Re: <u>NEC Electronics Inc.</u>

Phase IV Soil Investigation

Final Addendum 1

ADDENDUM 1 TO THE PHASE IV SOIL INVESTIGATION 501 ELLIS STREET PROPERTY REPORT

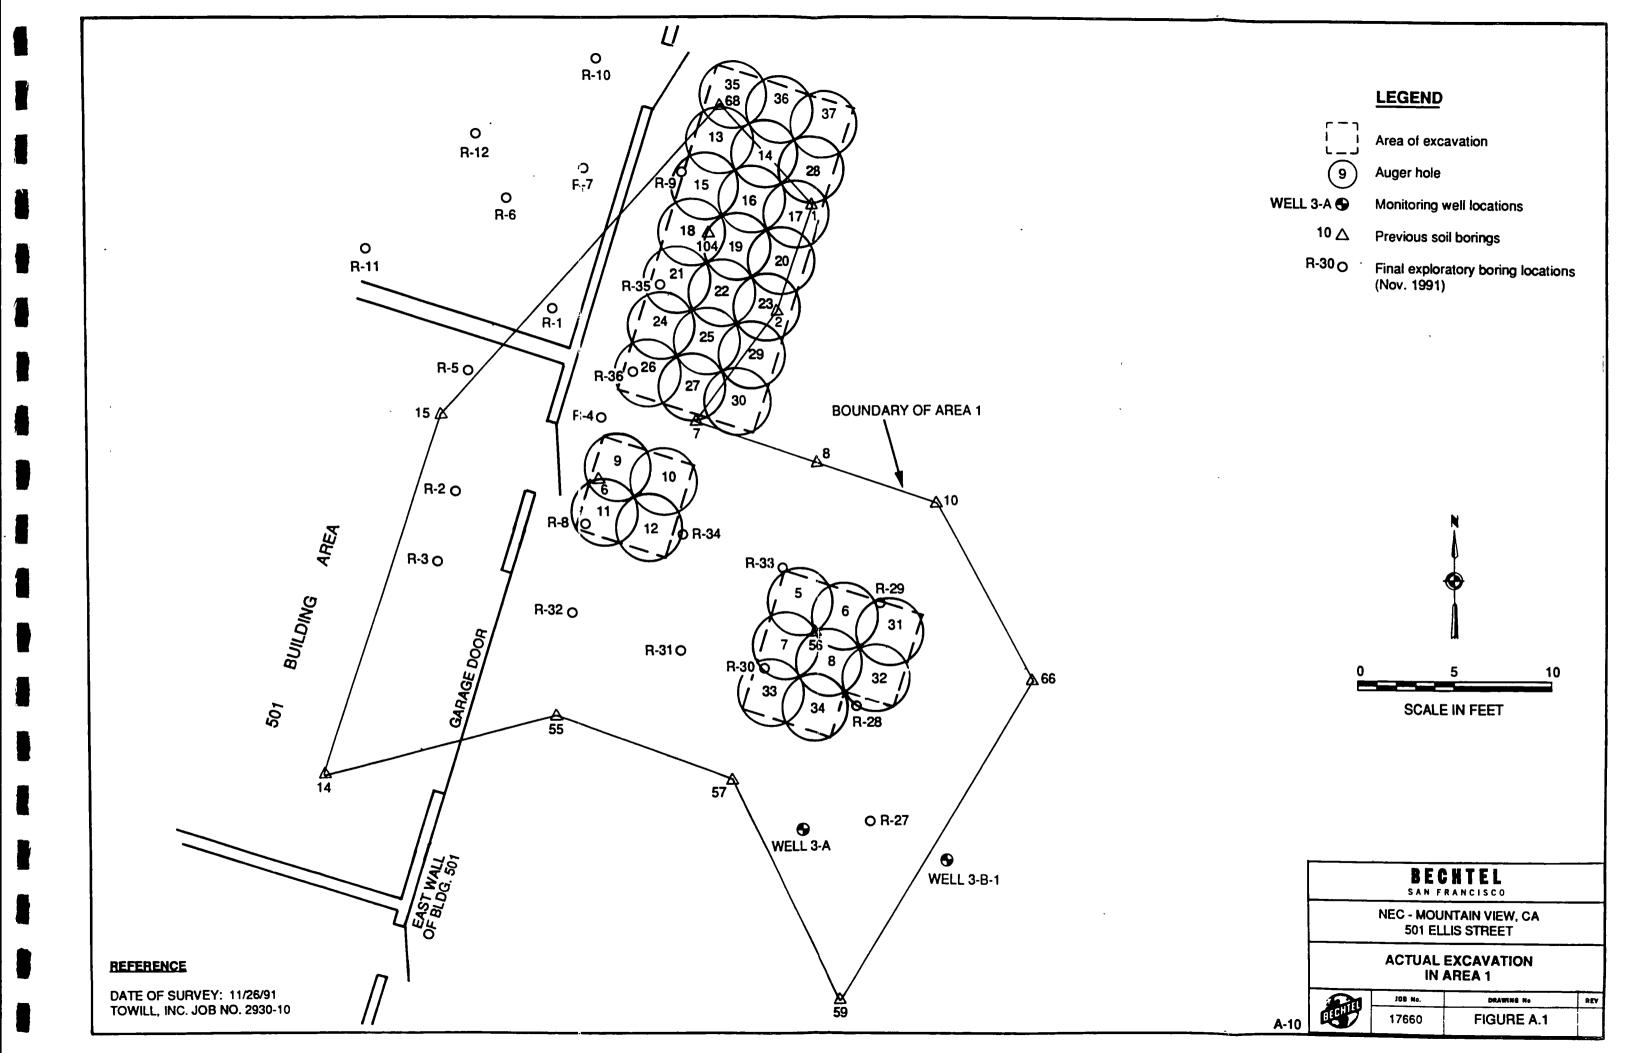
Any chemical, if it exceeds its clean up criteria will need to be remediated. In Section 4.0 (page 68), the text states that the occurrence of some of the chemicals was localized and infrequent with the exception of TCE. All detections, whether infrequent or localized, need to be evaluated in regards to their appropriate ARARs.

As shown in Table 1, the only sample collected during the Phase IV soil investigation which had concentrations of TCE and PCE that exceeded their respective cleanup criteria was collected from boring BIV-056 at a depth of 8 to 8.5 feet. Boring BIV-056 was located within the area excavated during the soil remediation conducted in 1991. The actual area excavated is shown in Figure A.1. (See also response to Comment 1.)

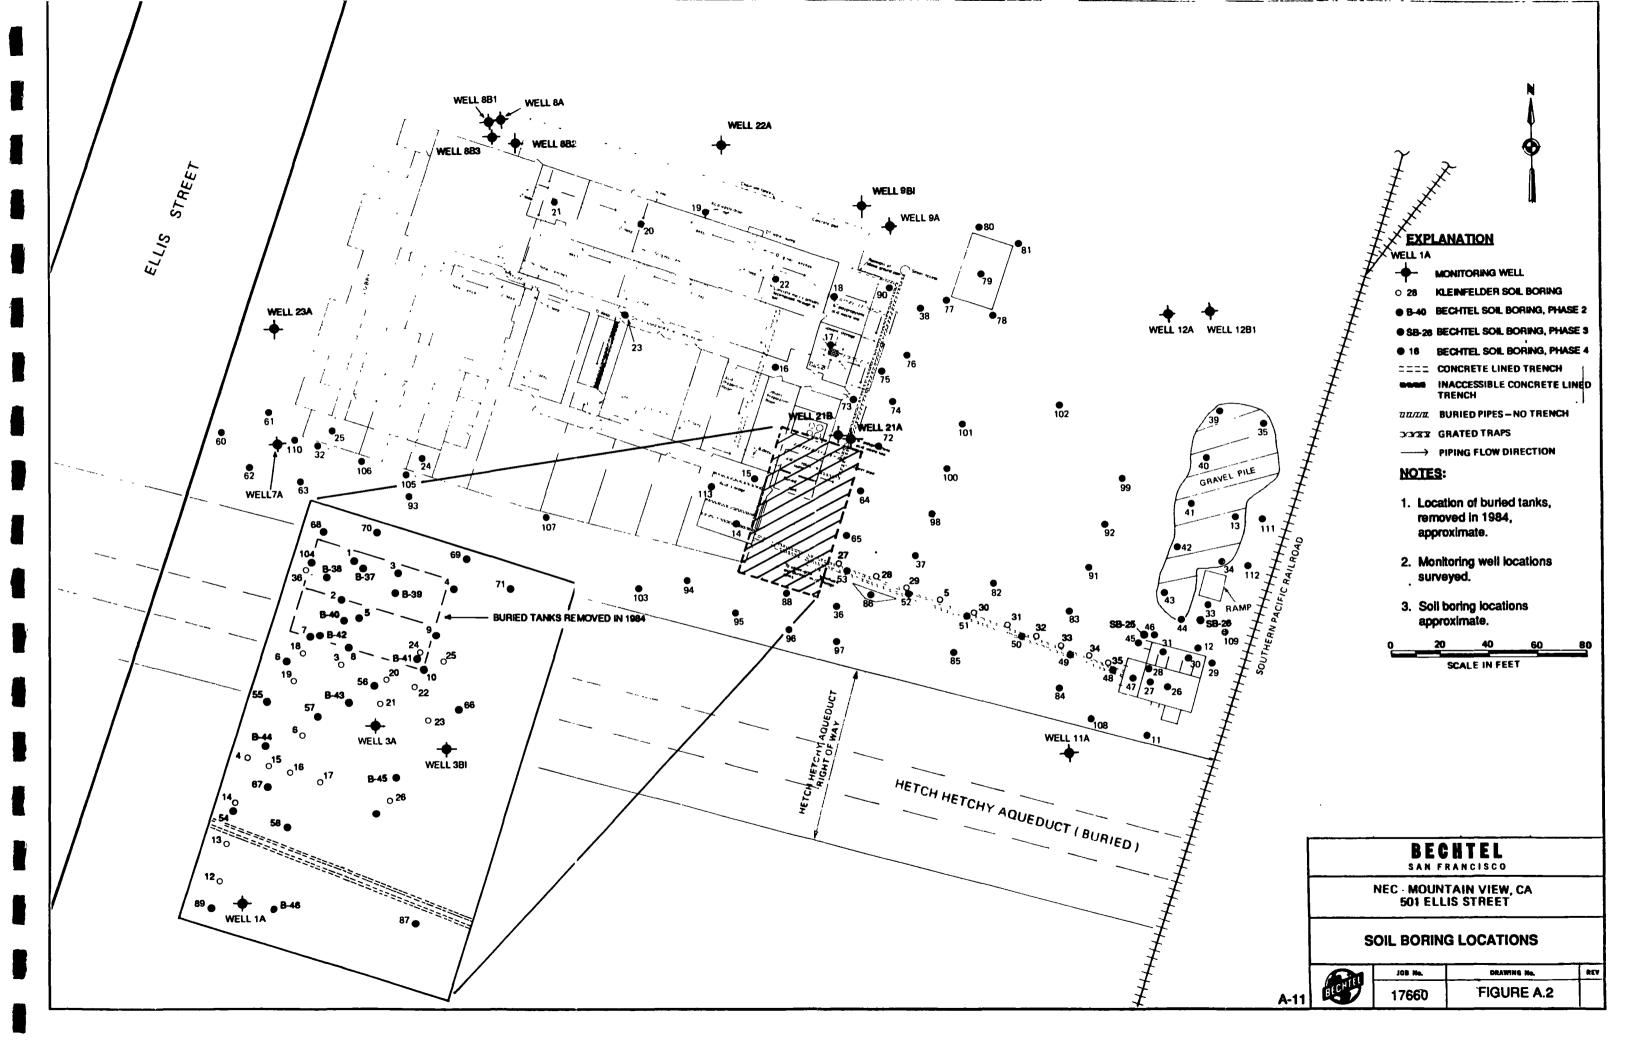
In general, the Phase IV Soil Investigation Report evaluates the presence of contamination in relation to the presence of trichloroethene (TCE) above the established clean up criteria of 0.5 parts per million in soil. Though evaluation of TCE concentrations is required, the 501 Ellis street property utilized many other chemicals that are also chemicals of concern as listed in the §106 Order. In reviewing the data and the occurrence of detections throughout the past investigations at the facility, there are several other chemicals that are present at the 501 facility which should be evaluated. Criteria for determining these chemicals should include the number of detections of the constituent and the presence of chemicals above their Federal or State applicable or relevant and appropriate requirements (ARARs). The explanation of Significant Difference clearly states that "all chemicals must be remediated so that their respective concentrations are at or below applicable or relevant and appropriate requirements and do not exceed maximum cumulative risk levels."

At a minimum the report should evaluate the following additional chemicals to determine if levels detected exceed ARARs, and the locations of these detections; freon 113, trichlorobenzenes, phenol, and tetrachloroethene. Locations of detections of freon 113 and trichlorobenzene were presented on figures 3.8 through 3.11, however there was no evaluation of their toxicity or clean up criteria. Table 1.5 shows that 1,2,4-trichlorobenzene and freon 113 have been detected in half of the samples analyzed for the constituents. TCE, 1,2,3-trichlorobenzene, and phenol have been detected in approximately one third of the samples analyzed. Though tetrachloroethene was detected less often, it was detected above the cleanup criteria at boring BIV-056.

Please evaluate the concentrations of these chemicals respective to the appropriate clean up criteria. In determining the appropriate ARARs for a constituent the

Four compounds collected from two soil samples exceed their respective soil cleanup criteria. These are: TCE and 1,2,4-TCB which were detected in the sample collected from boring B44, and benzene and vinyl chloride, which were detected in the sample collected from boring B37 (see Figure A.2).

<u>Vinyl Chloride</u>. The concentration of vinyl chloride (100 μg/kg) detected in the sample collected from boring B37 exceeds its respective cleanup criteria (50 μg/kg). The sample was collected from a depth of 3 to 5 ft bgs. Vinyl chloride was detected infrequently, in only two of 264 samples (1 percent) analyzed for volatile organic compounds (VOCs) during the Phase II investigation and in none of the 228 samples taken during the Phase IV soil investigation. It has not been detected in any of the ground-water monitoring rounds performed to date. Moreover, vinyl chloride was not found in samples collected from adjacent borings drilled during Phase IV (e.g., Borings 1 and 2 drilled within 5 ft of boring B-37). See Figure A.2.
